Docket No. 50-298

In licensing Amendment No. 67 issued January 30, 1981, Technical Specification pages 211 and 211a of your proposed amendment were inadvertently included instead of the amended pages.

Please replace these pages with the enclosed pages 211 and 211a as amended.

Figure 3.11-1.1 Maximum Average Planar Linear Heat Generation Rate versus Exposure with LPCI Modification and Bypass Flow Holes Plugged, Initial Core Fuel Type 3.

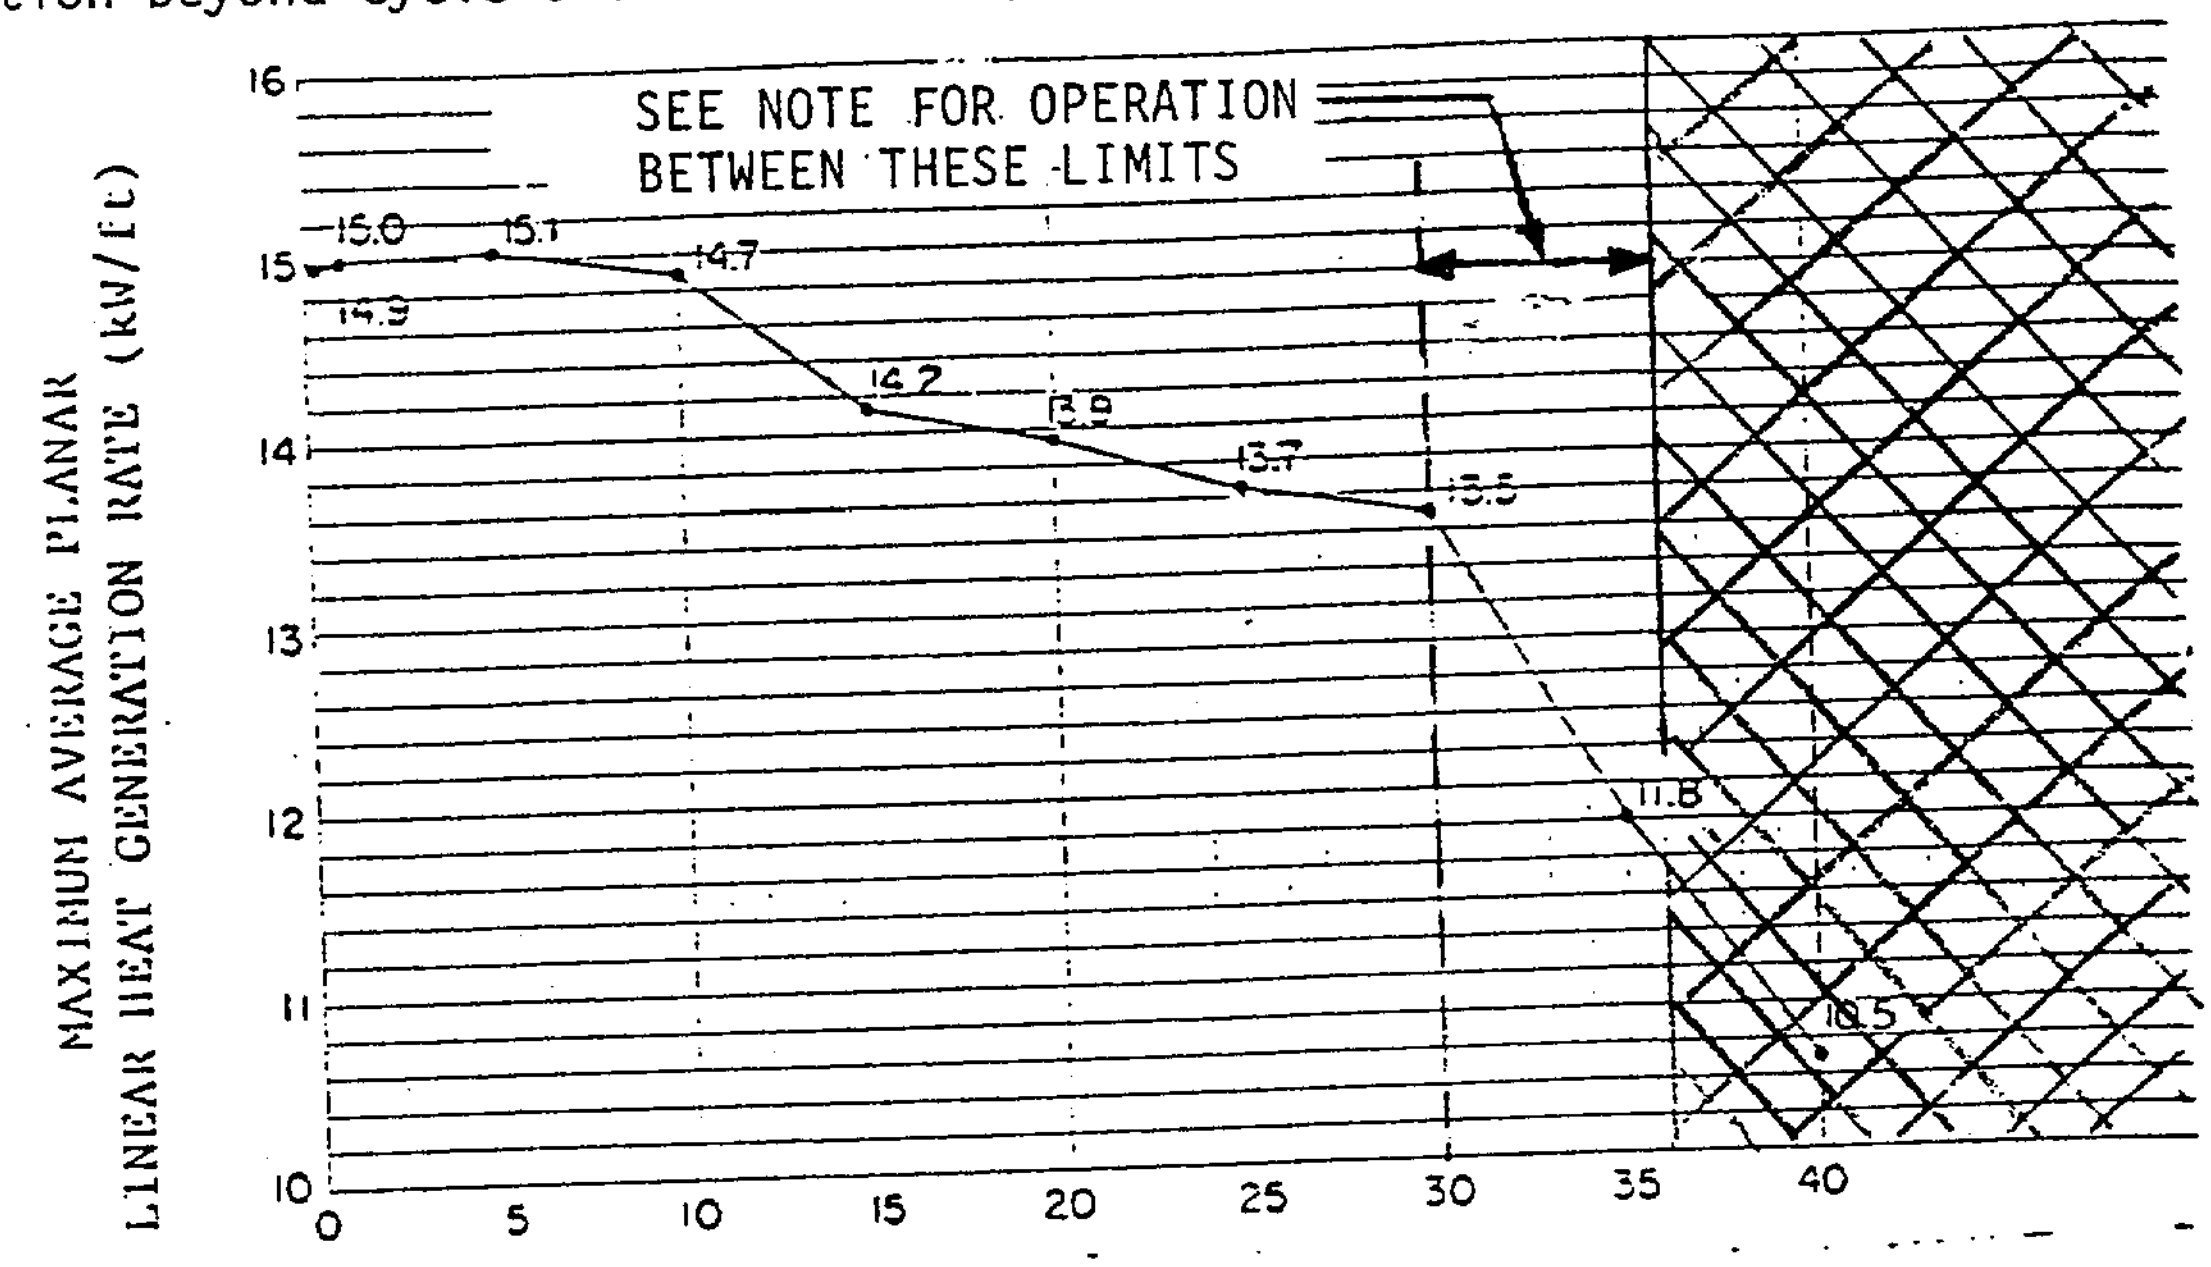
NOTE: Operation at planar average exposures above $30x10^3$ MWd/t a limited to $36x10^3$ MWd/t permitted for the remainder of cycle 6 if MAPLHGR limits reduced as follows:

Exposure MWd/tx10^3	30	32	34	36
Reduction in MAPLHGR, %	9.0	12.5	16.25	20.5

Operation beyond cycle 6 limited to 30,000 MWd/t.

Figure 3.11-1.3. Maximum Average Planar Linear Heat Generation Rate versus Exposure with LPCI Modification and Bypass Flow Holes Plugged, 8D250 Fuel

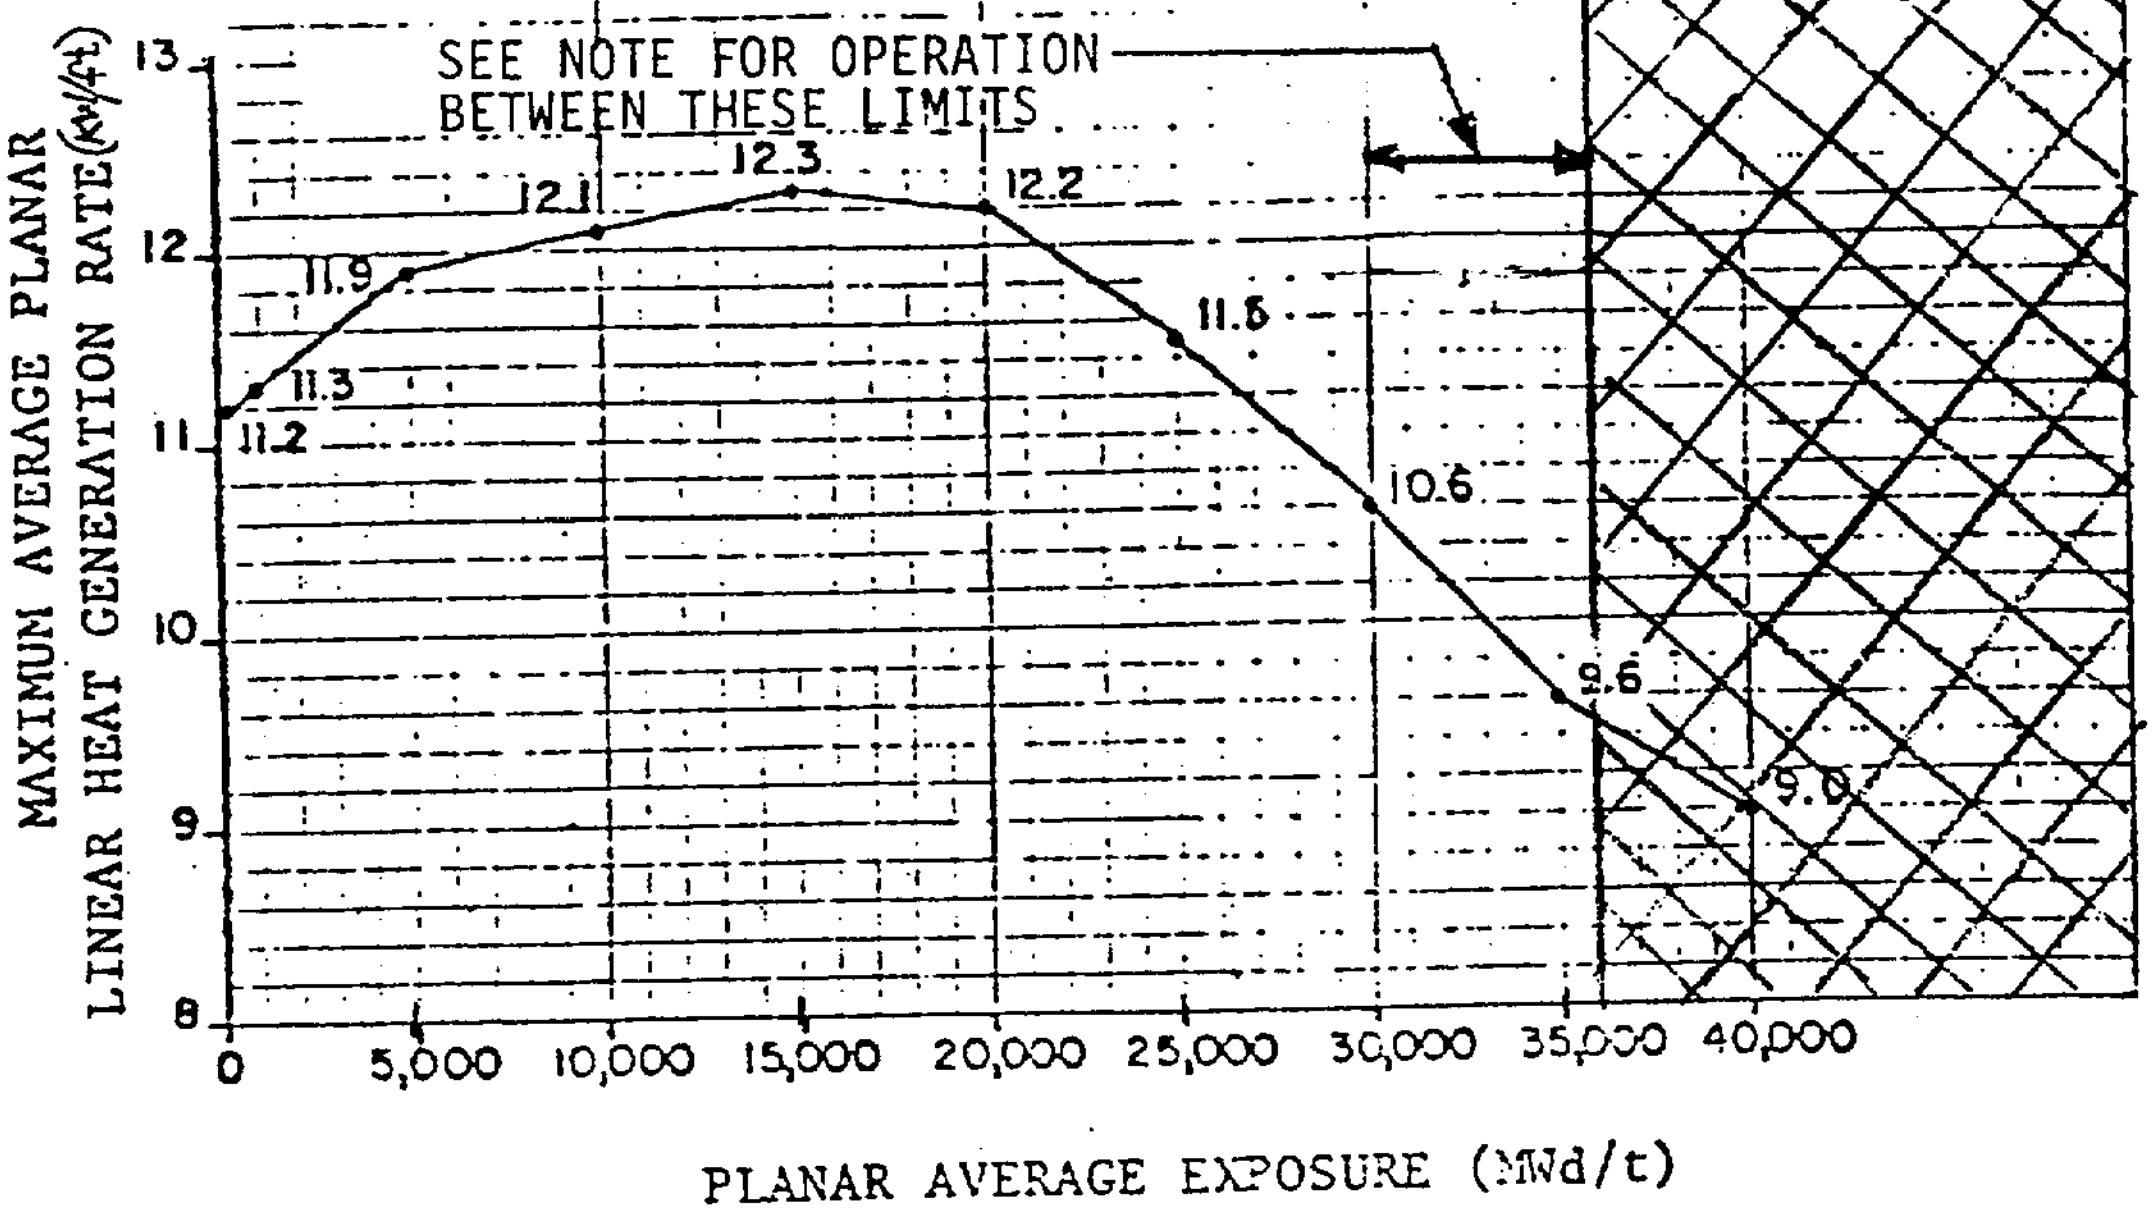
NOTE: Operation at planar a age exposures above $30X10^3$ MWd/t d limited to $36X10^3$ MWd/t permitted for the remainder of cycle 6 if MAPLHGR limits reduced as follows:

Exposure MWd/tX10^3	30	32	34	36
Reduction in MAPLHGR, %	9.0	12.5	16.25	20.5

Operation beyond cycle 6 limited to 30,000 MWd/t.
